Bsides 2025 Badge

Preliminary Hardware Failure Analysis Report

Focus: Analysis of IC (IP5305T / U2) and Power Stage Failures

Revision: 3

5.4. Inductor Vpp and Current @ Isat (Iload: 680mA – Device shuts down):

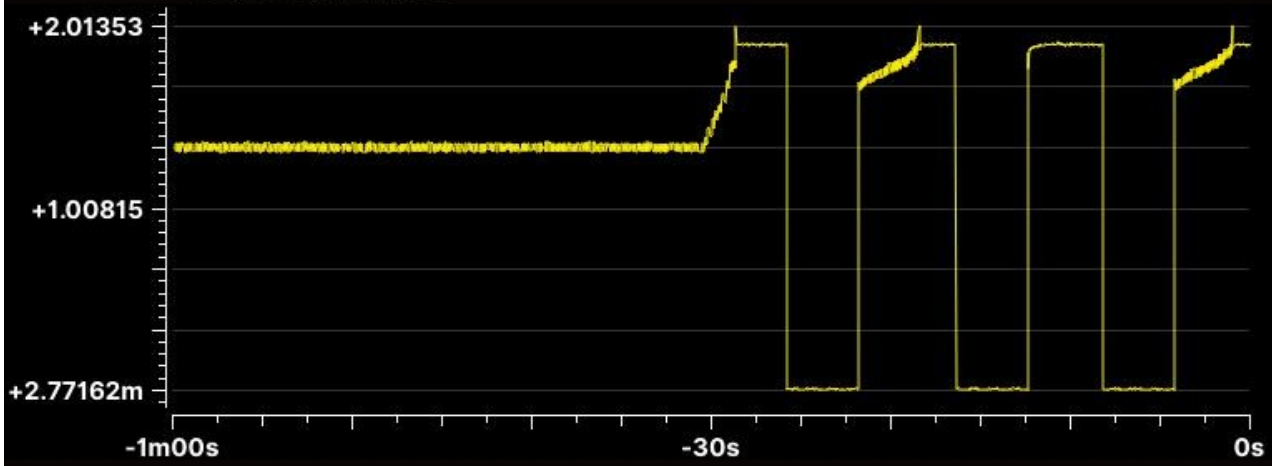
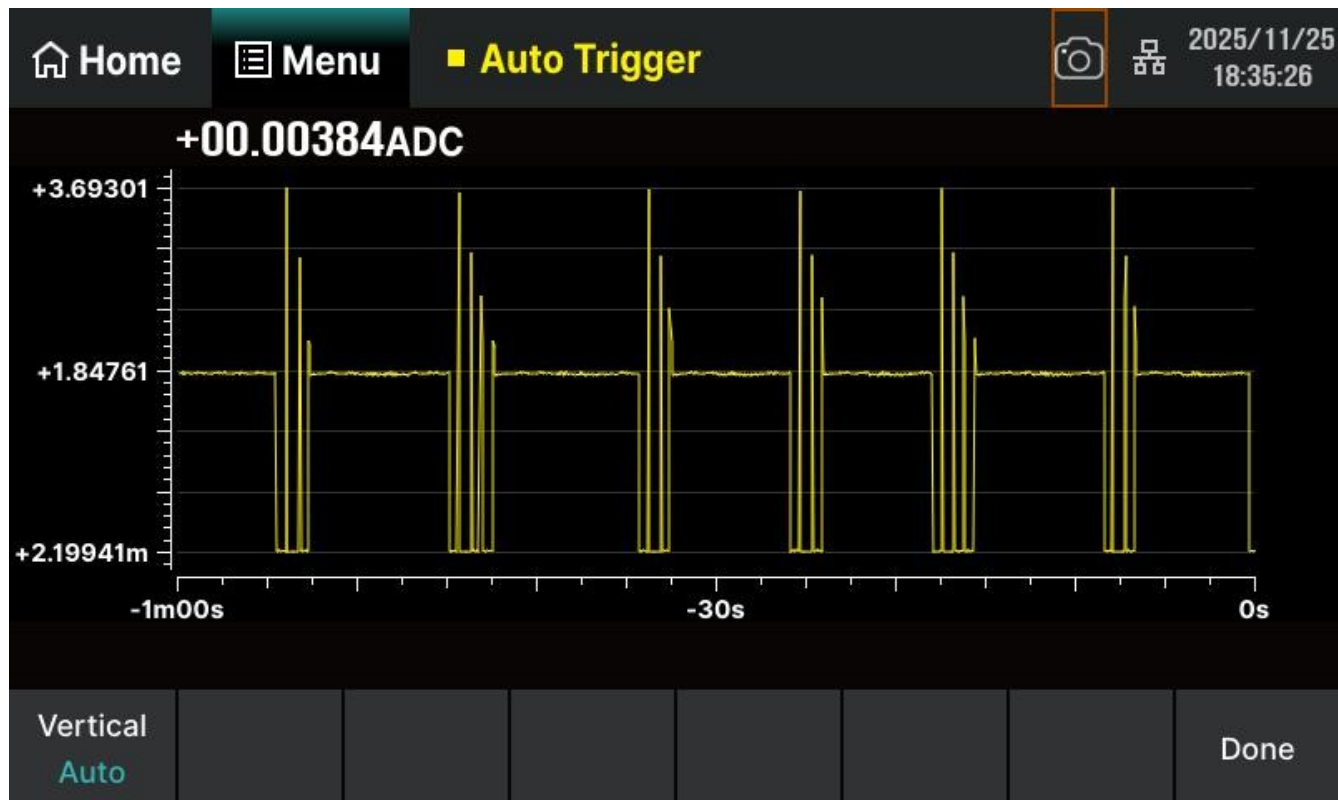
- When the inductor core saturates (5.4), excessive* current may flow through the U2 FET and the switching node.
- Excessive* current may flow through the U2 internal FET during Wi-Fi transmissions from the ESP MCU (U1), as short, high di/dt pulses draw current from the power source and through the boost stage.

- Repetitive pulsed operation may gradually degrade the IC (U2) and/or inductor (L1), particularly when current the peaks approach the inductor (L1) saturation current (I_{sat} , 5.4).

- Select an inductor (L1) with a higher current saturation margin (I_{sat}).
- Include a snubber network between the switching node and a low-impedance reference node to limit the peak amplitude of voltage overshoot during FET turn-off.

5.7. Peak Temperature observed @ 780mA Iload (pulsed, 10ms, 50% duty cycle):

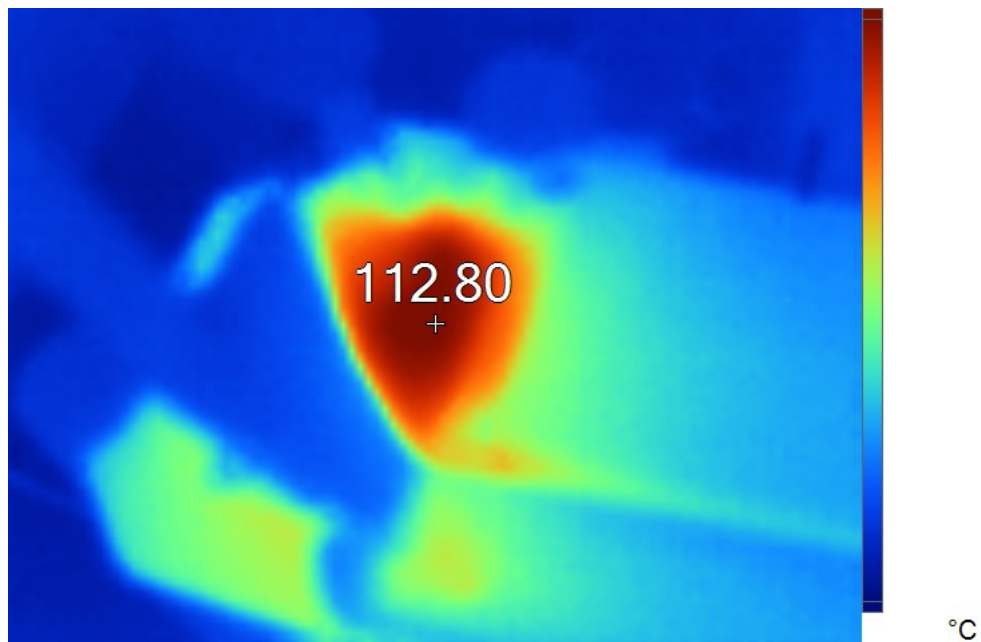
- 112.8 Celsius (assumed junction temperature to be between 20 to 50 Celsius higher).

It is difficult at this stage to conclude which specific test contributed the most to this degradation, as the IC (U2) was traced after testing, rather than between each test. It is, however, suspected that the degradation occurred during the measurements shown in (5.6) and (5.7), which subjected the IC (U2) to the highest combined thermal and electrical stress.

5.8. I-V Curve trace for a unused IP5305T (picked directly from a reel):

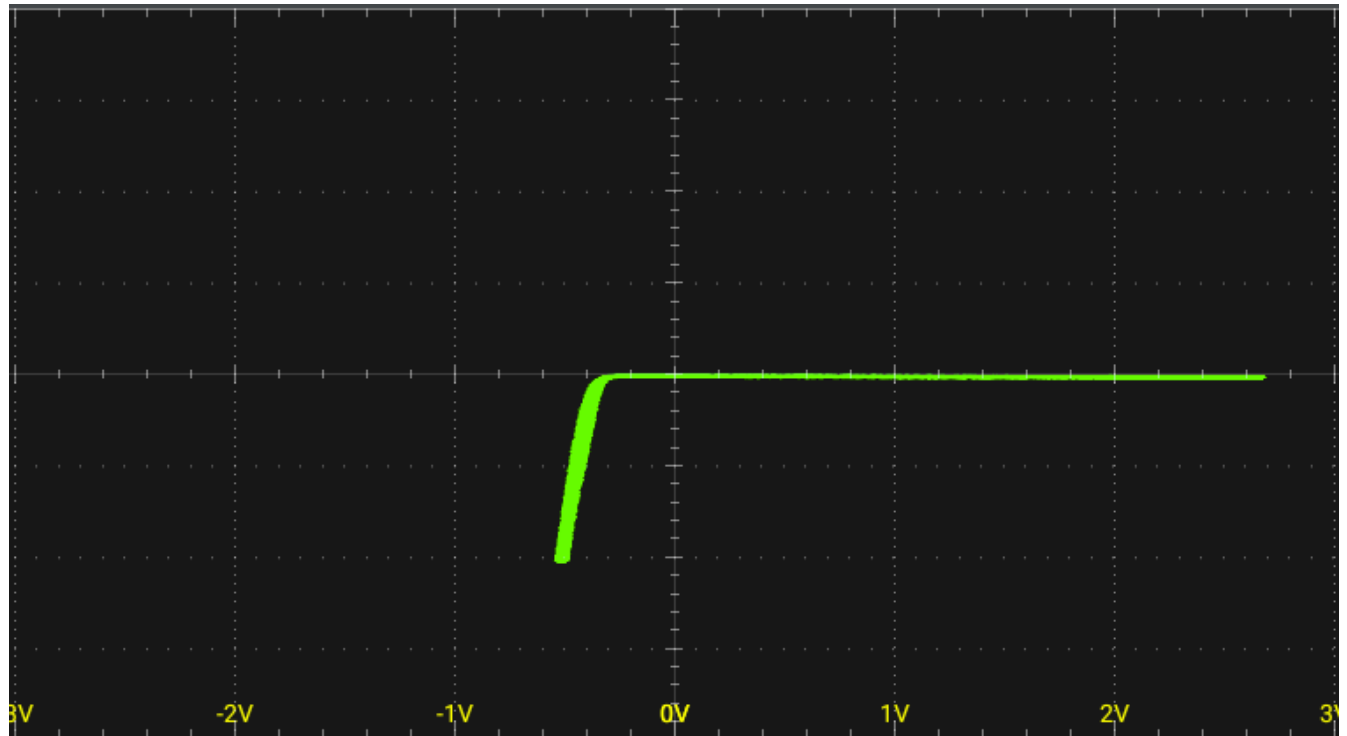
The IC (U2) was de-soldered from the DUT and an I-V curve trace was performed between the SW and PowerPAD connections. The resulting curve for the suspected degraded IC (U2) can be seen in (5.9) and compared with the I-V curve of an unused IC in (5.8).

5.9. I-V Curve trace for a IP5305T after being subjected to the previous tests:

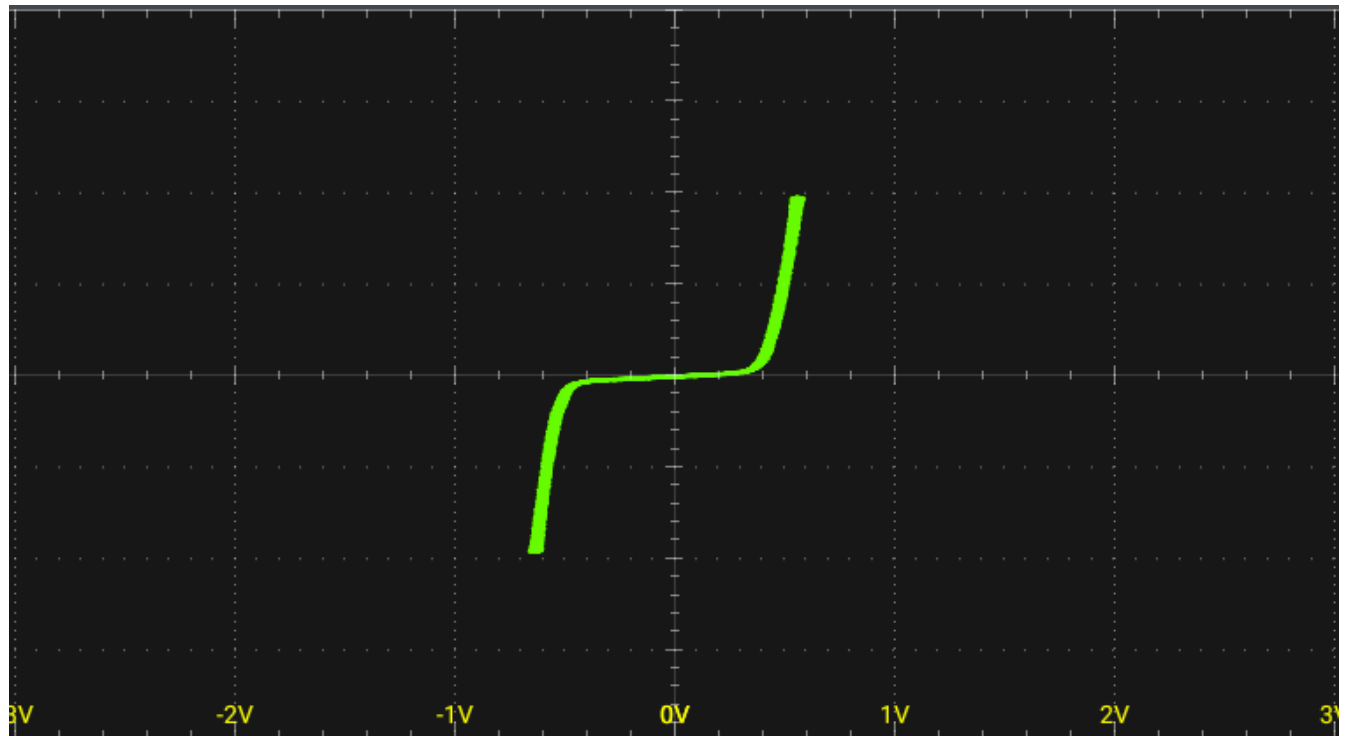
The IC (U2) and inductor (L1) combination in the DUT was subjected to large current peaks (3.7A) during the tests (5.5), which may have contributed to the degradation of the IC (U2), as seen in (5.9).

These results indicate that, for the suspected IC (U2), a current conduction path exists between SW and PowerPAD when a positive voltage is applied across the terminals. Although the exact degradation mechanism cannot be determined from this measurement alone, the observed behavior is consistent with degradation of the internal silicon structures associated with the switching FET. As conduction begins at lower applied voltages, the effective resistance between SW and PowerPAD is reduced. This can lead to increased static current and higher power dissipation during operation, increasing the risk of thermally induced failure.
